Access Compliance Report

Public Rights-of-Way

(Pedestrian Signals)

Intersection ID: N/A	Main Street:	Cross Street: N/A	Location: N/A
ADA ID: B9B3FAC3362A	Signal Type: One Push Button-Non APS	Overall Compliance: No	Severity Score: BTN 1: N/A BTN 2: N/A No BTN: N/A
Codes/Mitigation Info/Possible Solution		Field Measurements/Component Compliance

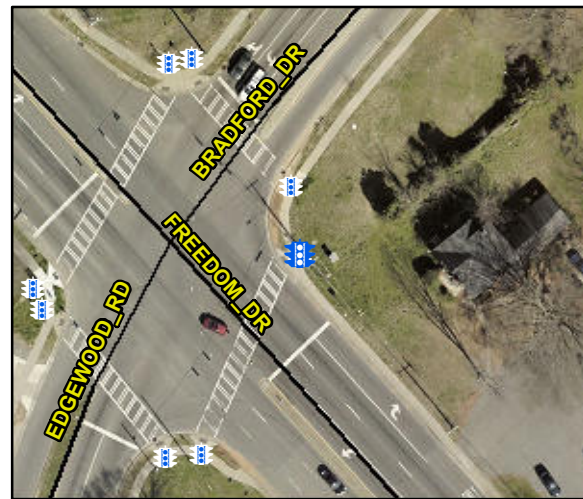
PROW/ADA: TMUTCD 4e.08, R406.2, R404.7.3

Possible Solutions: Replace Signal Push Button With APS Button on New Post. Remove & Relocate Sign.
